Facilities Subcommittee Report

RE: Structural Engineering Review of Roofing Installation

New Milford High School

Fuss & O'Neill Reference No. 20191275.K10

Photo 4: Excessive fastener spacing at gable end

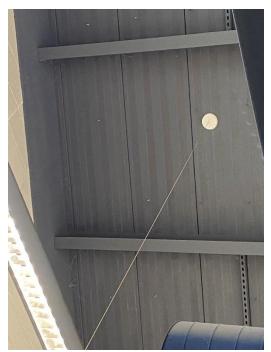
- 2. Single screws were noted at many locations in all the spaces observed (see photos #2 & 3).
- 3. In all the spaces observed, the spacing of screws varied significantly. There were areas where the spacing exceeded 5 feet (see photo #4), which was the maximum spacing indicated on the Garland shop drawings. Some, but not all, of these variations relate to dormers on the roof.
